SUBJECT **Update requested to the Auckland Unitary Plan
(Operative in Part 2016) (AUP)**

NOTICE OF MINOR ALTERATION OF DESIGNATION 1713 UNDER S181(3) OF THE RESOURCE MANAGEMENT ACT 1991

Alteration and removal to Designation 1713 – Waterview Shared Path in the Auckland Unitary Plan (Operative in Part)

Figure 2: Alteration to Designation 1713

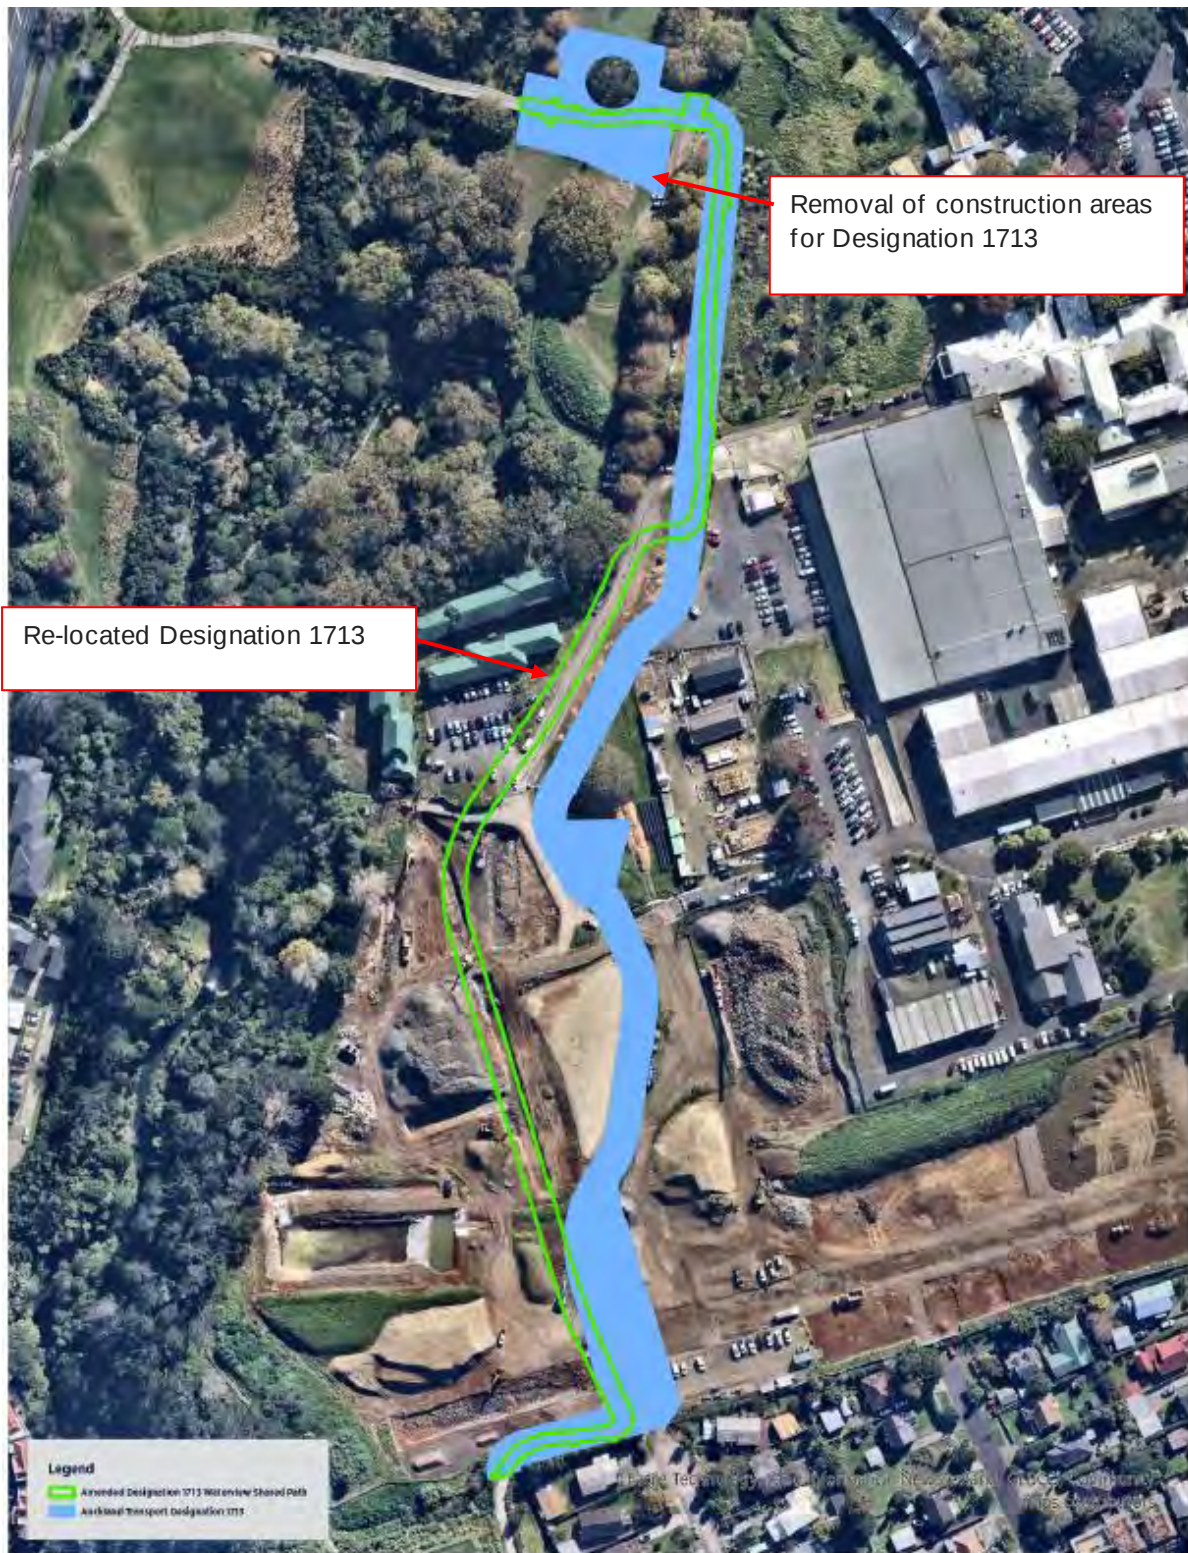
Address	Legal Description	Certificate of Title	Change to designation
26 Rhodes Avenue, Mount Albert	Lot 2 DP 515012	799989	1,404m ² originally, reduced to 256m ²
36 Laurel Street, Mount Albert	Sec 348 SO 434446	579605	1,256m ² originally, reduced to 607m ²
127 Carrington Road, Mount Albert	Lot 3 DP 515012	799990	126m ² originally, increased to 1,298m ²
111 Carrington Road, Mount Albert	Lot 11 DP 580984	1195432	4,740m ² originally, reduced to 1,413m ²
131 Carrington Road, Mount Albert	Section 2 SO 573867	1071371	338m ² originally, reduced to 0m ²
121 Carrington Road, Mount Albert	Lot 3 DP 314949	58981	1,586m ² originally, reduced to 236m ²
123 Carrington Road, Mount Albert	Lot 2 DP 314949	58980	328m ² reduced to 0m ²
Total (7 parcels)			9,781m ² reduced to 3,813m ²

Figure 2 below demonstrates the changes to Designation 1713.

Figure 1 - Designation 1713 Amendment Waterview Shared Path map. Source: AT.

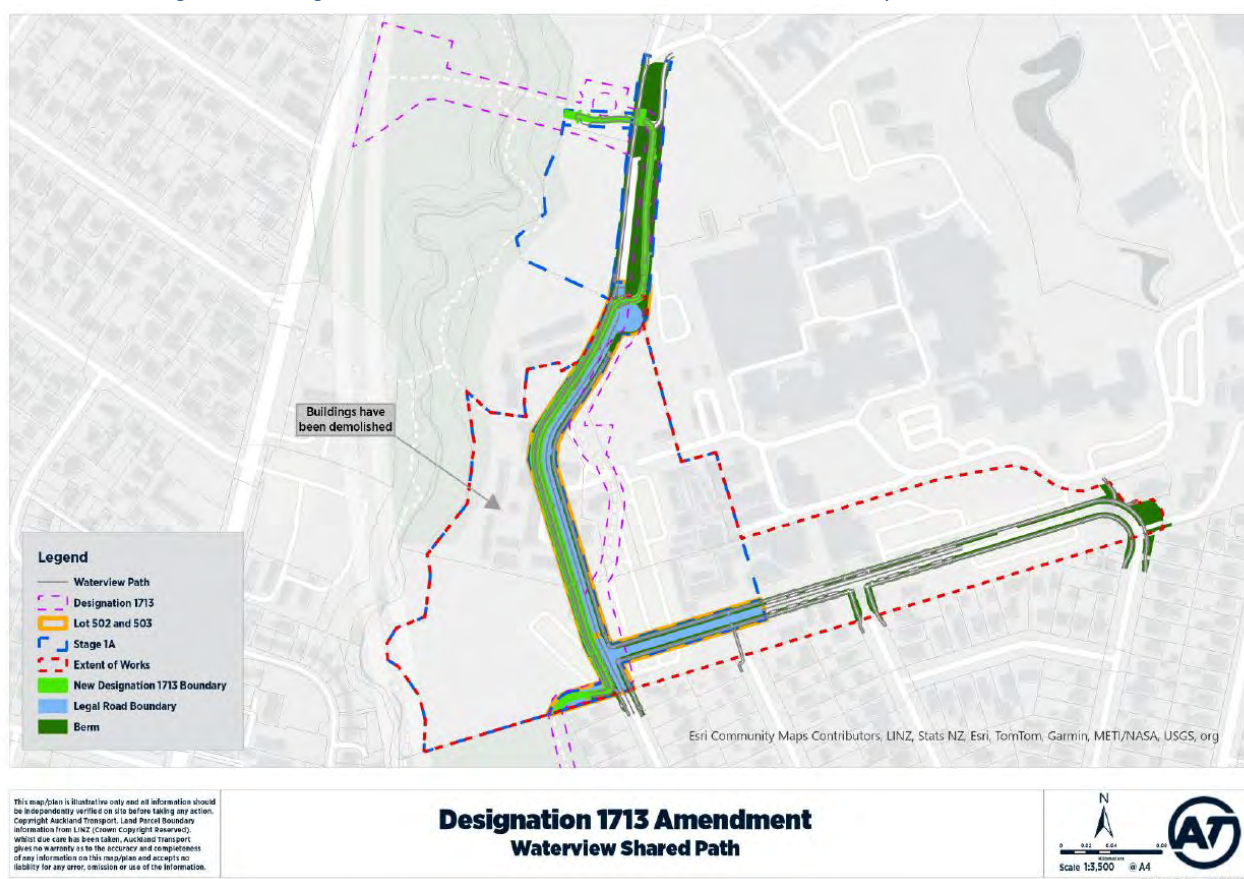
The designation boundaries are proposed to be altered to align with approved consents - Unitec Residential Development – Wairaka Stage 1, approved on 3 May 2023 and BUN60419728 & SUB60419729 approved on 3 May 2024 (refer to Figure 1). North of the approved consents, the designation is proposed to be narrowed to provide for the existing shared path which is currently in use. Provision for a maintenance strip which includes all infrastructure (e.g. lighting, signage) will be included within the altered designation. The proposed alteration involves:

- Altering the area of the designation directly adjacent to 139 Carrington Road (Unitec site), in accordance with the consented plans which provides for the shared path to be moved to the west and for a public road to the east along the southern portion of the boundary.

The proposed alteration reduces the area of land occupied by the designation over seven land parcels from 9,781m² to 3,813m², a reduction of 5,967m² (61 per cent) (Source: Auckland Transport, AEE, March 2025 **Attachment C**). Changes to the size and layout of land available for development within the Wairaka precinct will occur as a result of the alteration. No change to the purpose or use of the shared path is proposed.

Figure 2: Existing Designation 1713 (blue) and altered Designation 1713 location (green)

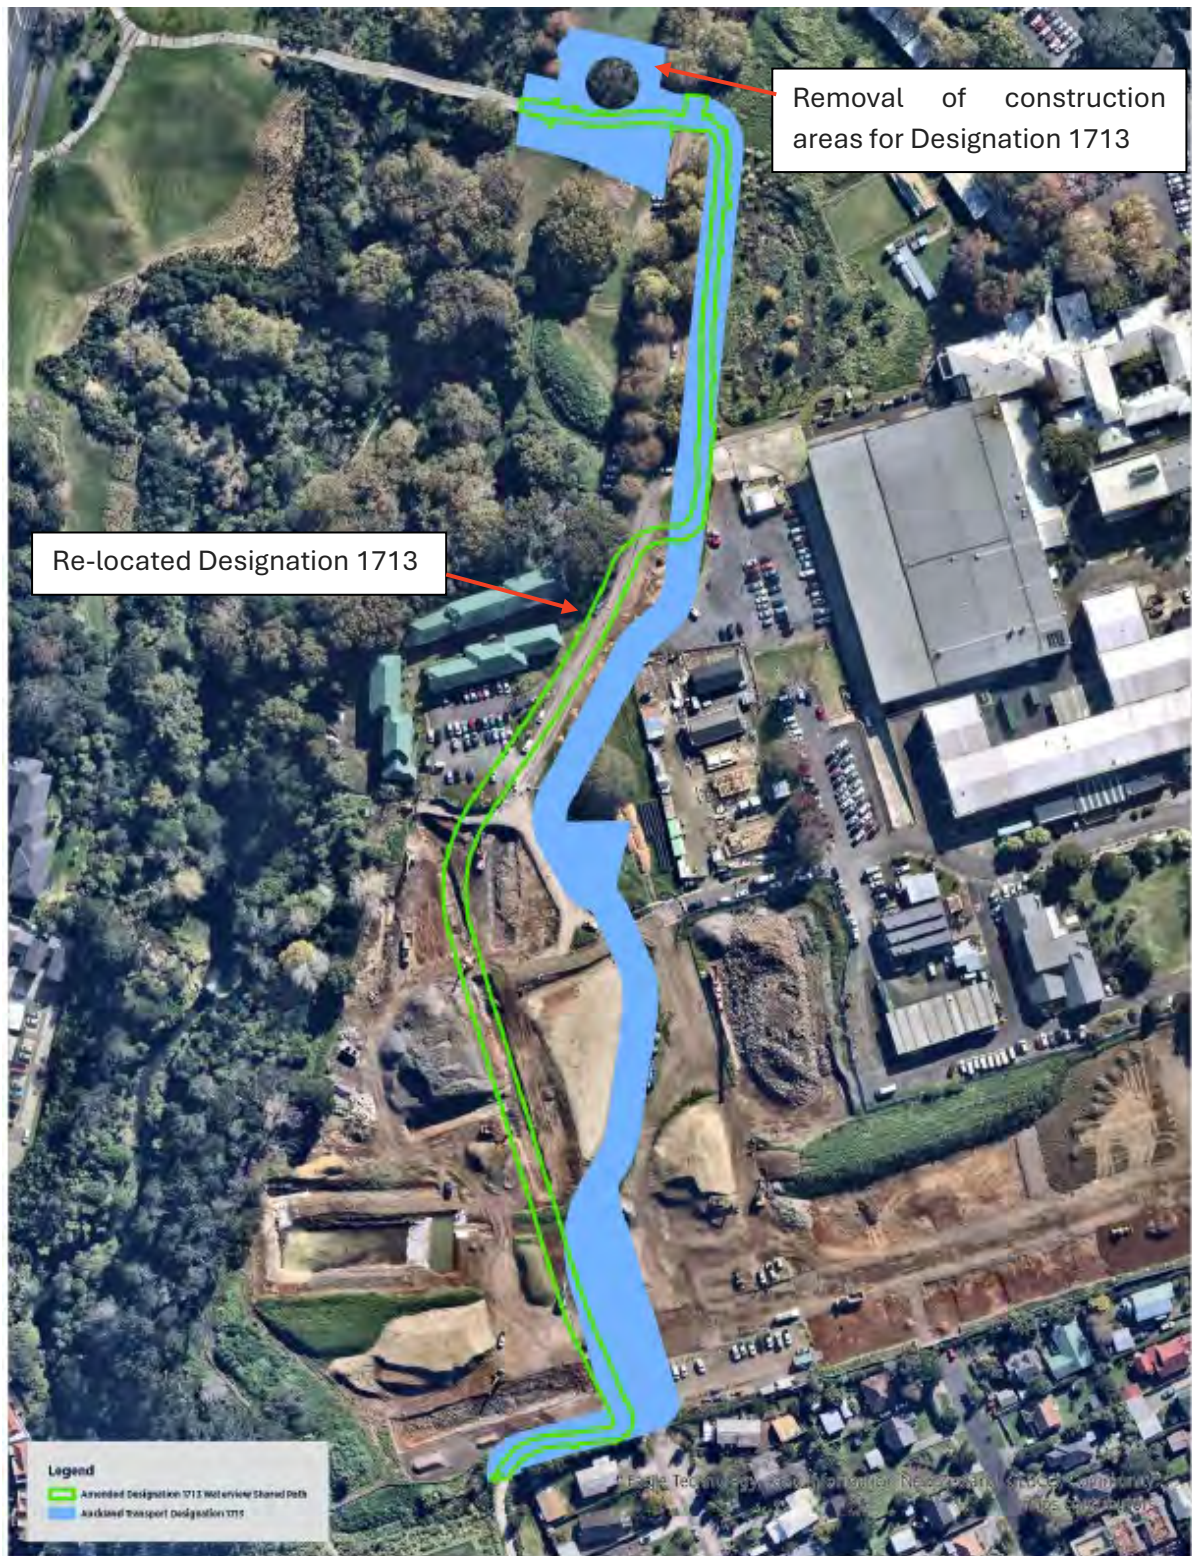
AT is seeking to alter and remove parts of Designation 1713, moving it west of the current location by 40m at the greatest point. The new location will be adjoining the extension of Laurel Street that is currently being undertaken by Ngāti Whātua Ōrākei, the extension being authorised by approved consents and to be vested as road. No new landowners are affected and the altered Designation will be contained within the same land parcels as it's current location. The altered shared path facilities will be upgraded into a separated footpath and bi-directional cycle lane. The new designation boundary compared to the existing boundary is shown in **Figure 2**, with Plans shown in **Appendix B**.

The change to Designation 1713 is considered to be minor as it is located within the same affected land parcels, is moving to match the existing environment, will be located on a vested road and tie into the existing path alignment to the north and south, does not include any physical works and will decrease (reduce the impact) of the designation by 5,967m². It is considered the application aligns with Section 181(3)(a)(ii).
